# Errata for the PCI Express Base Specification, Revision 1.0a

28 October 2004

**Figure 5-1: Link Power Management State Flow Diagram ~~Transitions~~ *<edit figure as shown>***

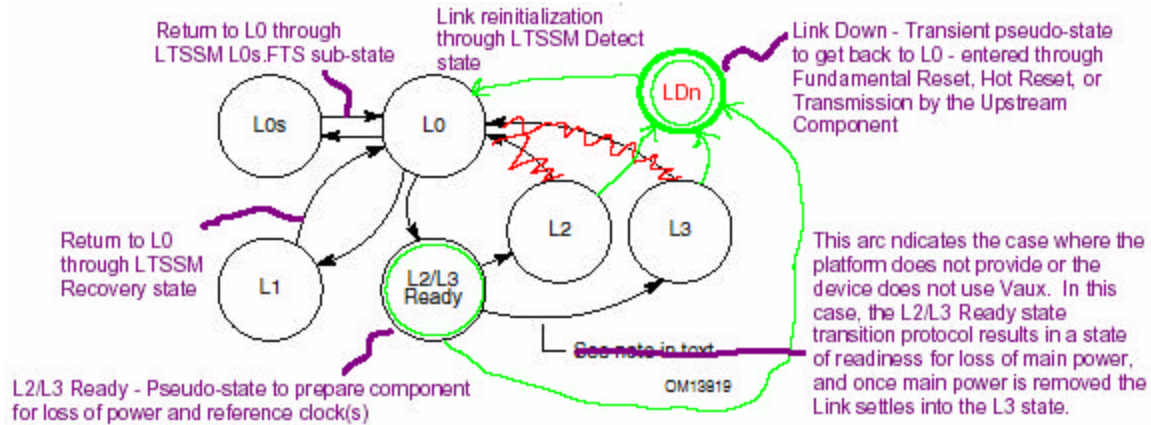
Figure 5-1 highlights the legitimate L-state transitions that may occur during the course of Link operation.

**Figure 7-8: Power Management Capabilities Register**

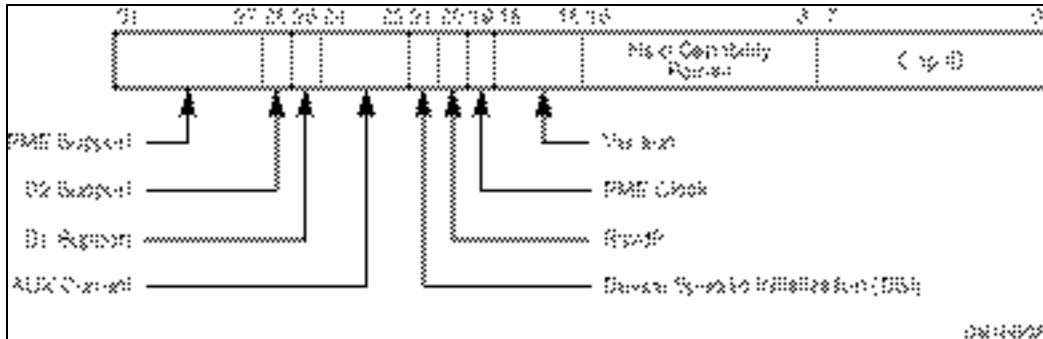
Figure 7-8 details allocation of register fields for Power Management Capabilities register; [and](#) Table 7-7 [describes the added requirements](#)~~establishes the mapping between PCI 2.3 and PCI Express~~ for this register.

Figure 7-9: Power Management Status/Control Register

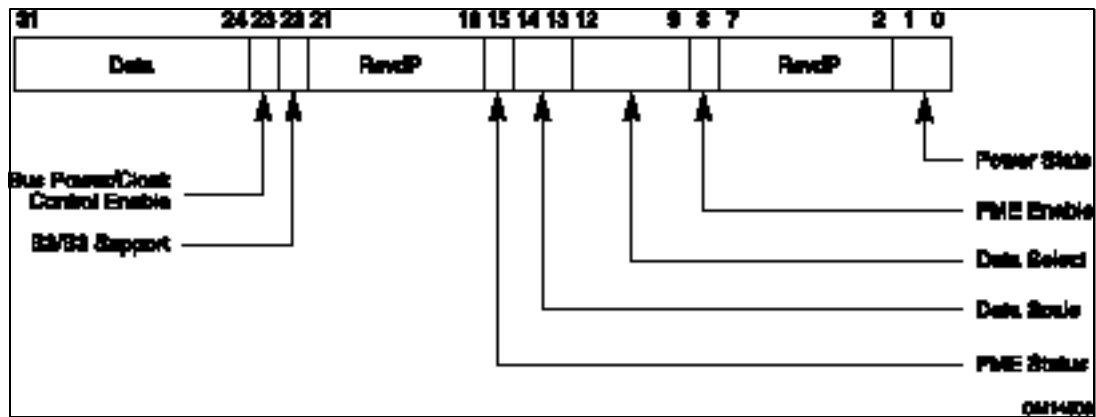
Figure 7-9 details allocation of register fields for Power Management Status and Control register; [and](#) Table 7-8 [describes the added requirements](#)~~establishes the mapping between PCI 2.3 and PCI Express~~ for this register.

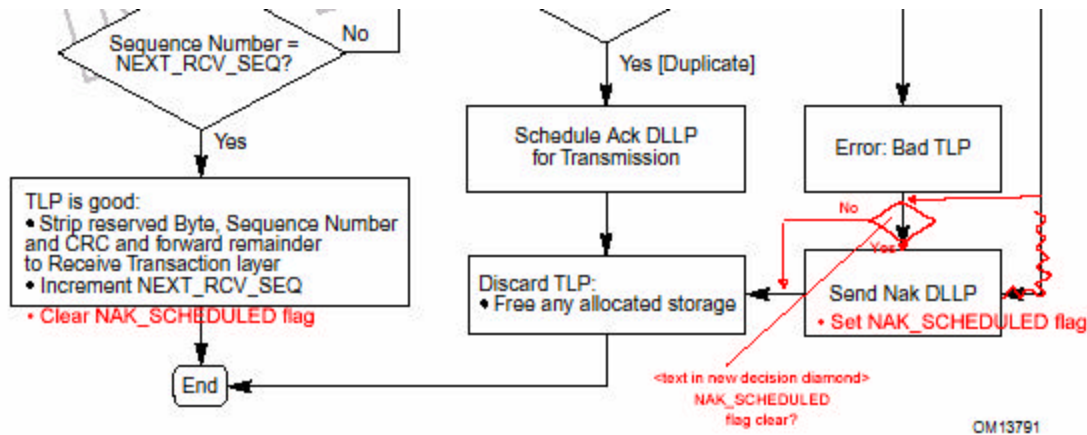
On the top page of 233, change equation 4.3 from:

$$H_d(\mathbf{w}) = \left| \left( \frac{s}{s + \mathbf{w}_3} \right)^3 \right|$$

$$H_d(w) = \left| 2 * \left( \frac{s}{s + w_3} \right)^3 \right|$$

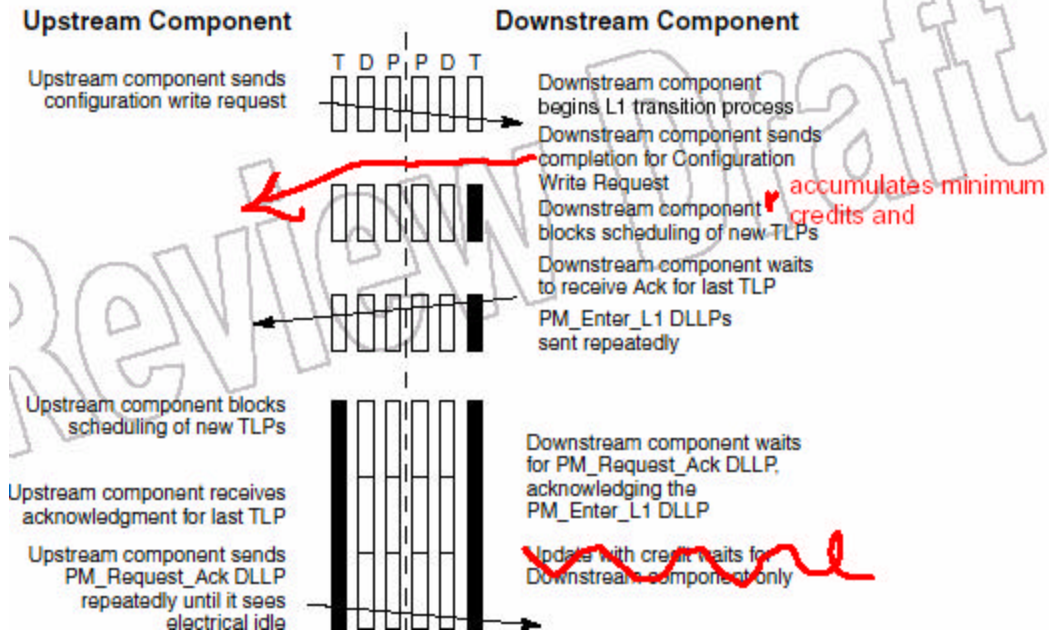
*The text in the figure for the downstream component does not mention waiting to accumulate credits – Edit Figure 5-3 (Sect 5.3.2.1) "Entry Into the L1 Link State" as shown [Note: This figure used to be Figure 5-2; Unchanged parts of figure not shown]:*
